KANSAS GAS AND ELECTRIC COMPANY

KMLNRC 84-118

Subj: Technical Specifications

# TECHNICAL SPECIFICATION CHANGES

Figure 5.1-4  
Boundary for Liquid Effluents

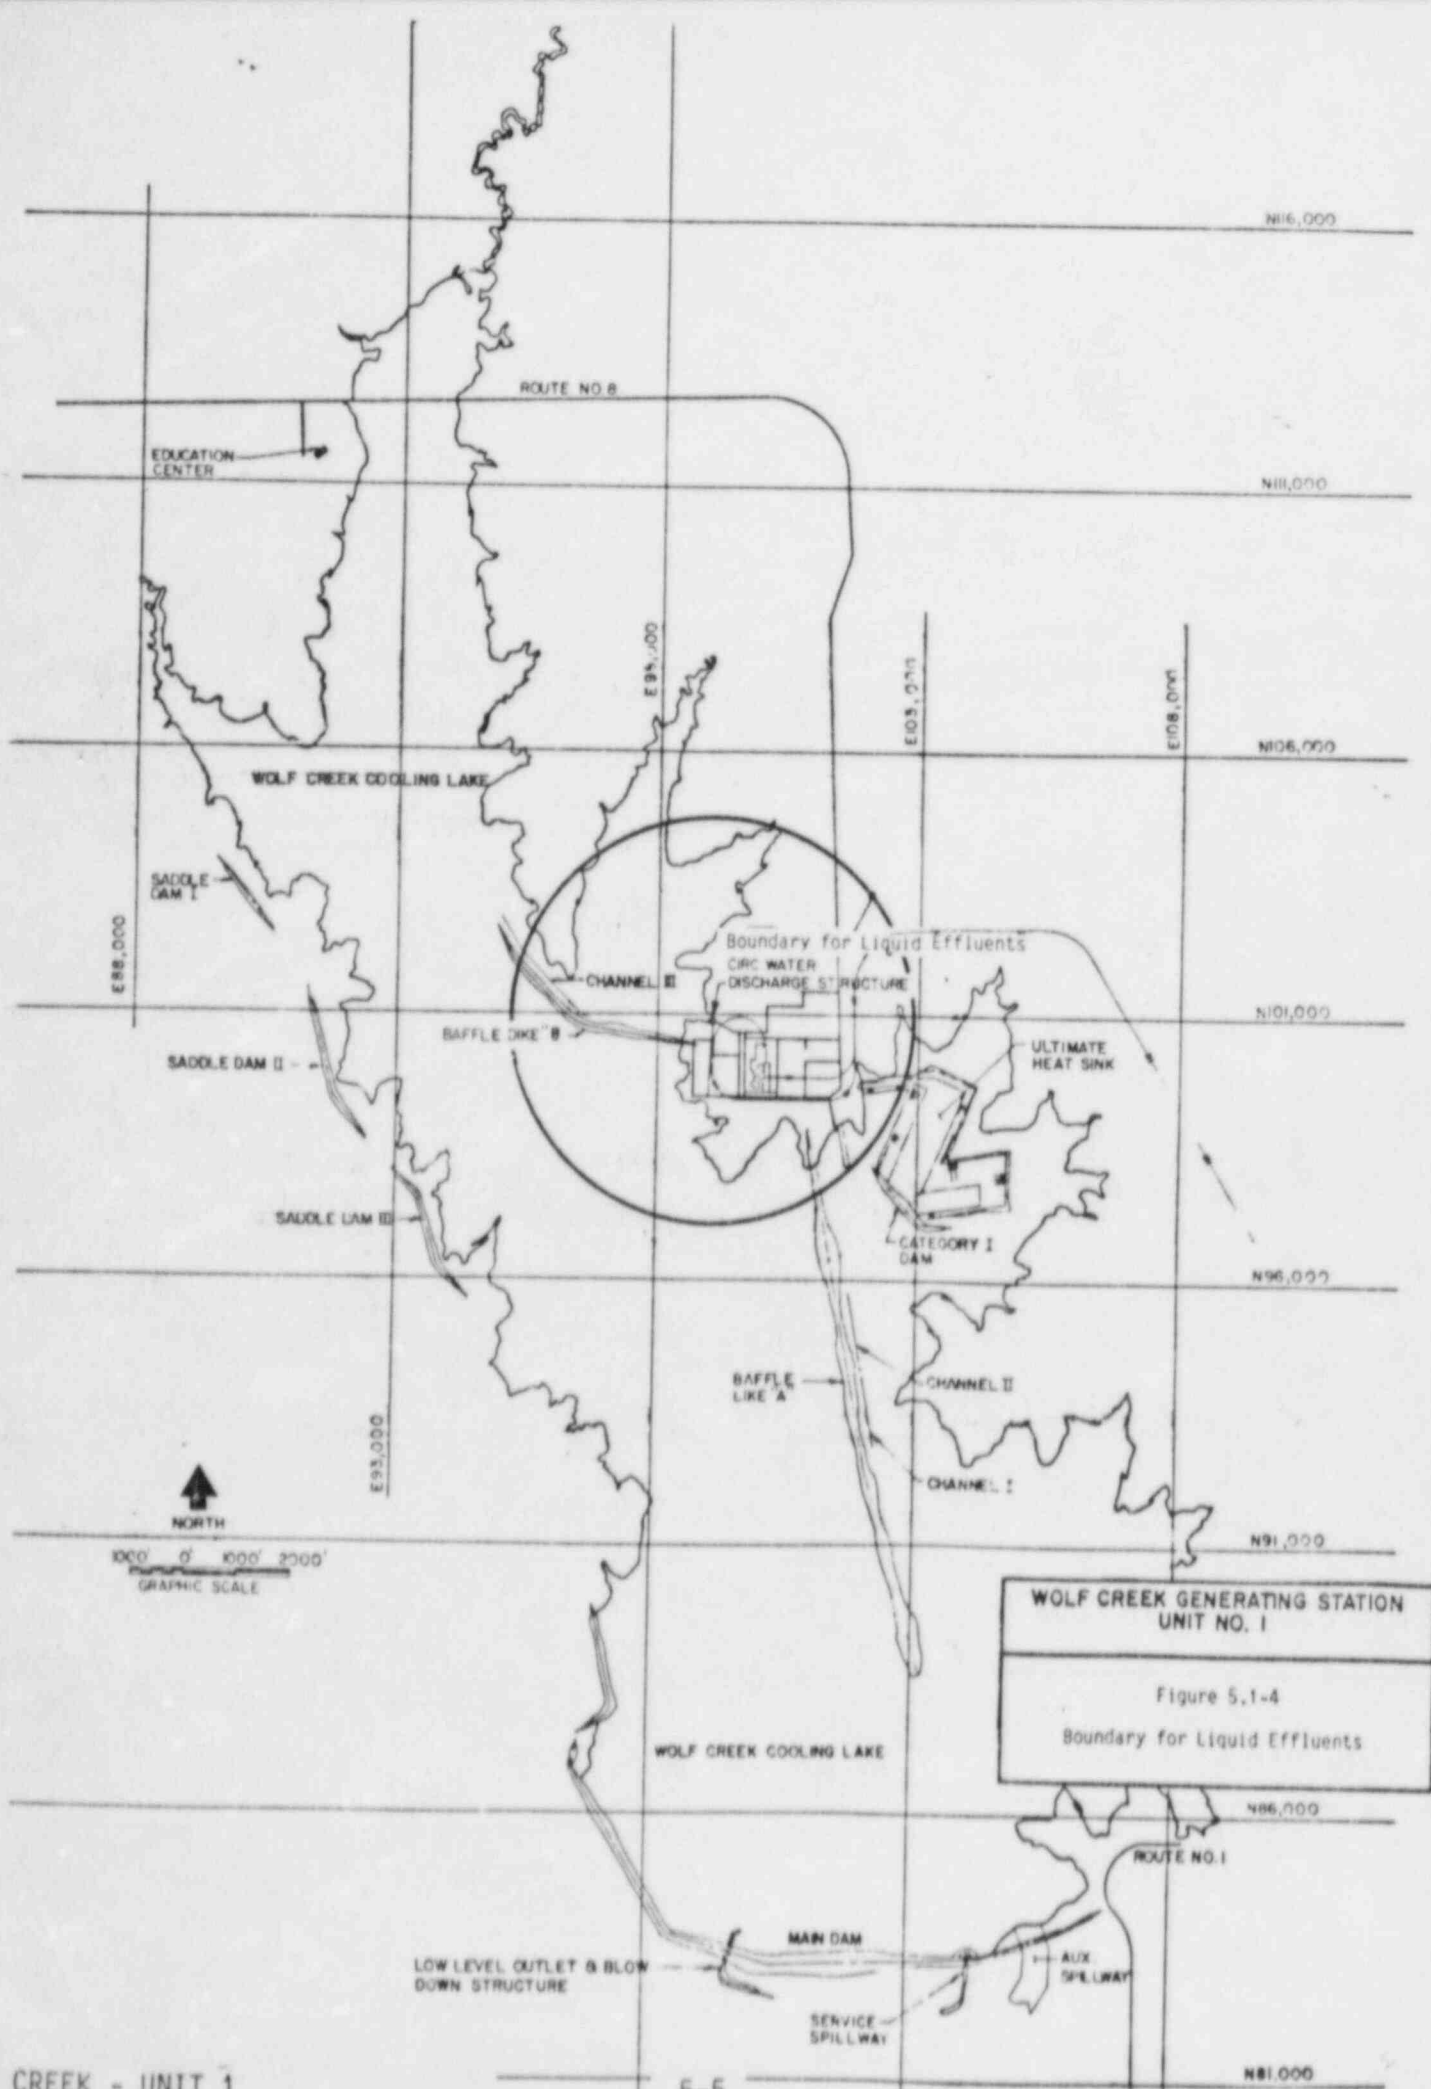
5-3	Figure 5.1-2	Wolf Creek specific justification provided
5-4	Figure 5.1-3	Wolf Creek specific justification provided
5-5	Figure 5.1-4	Wolf Creek specific justification provided

Figure 5.1-4
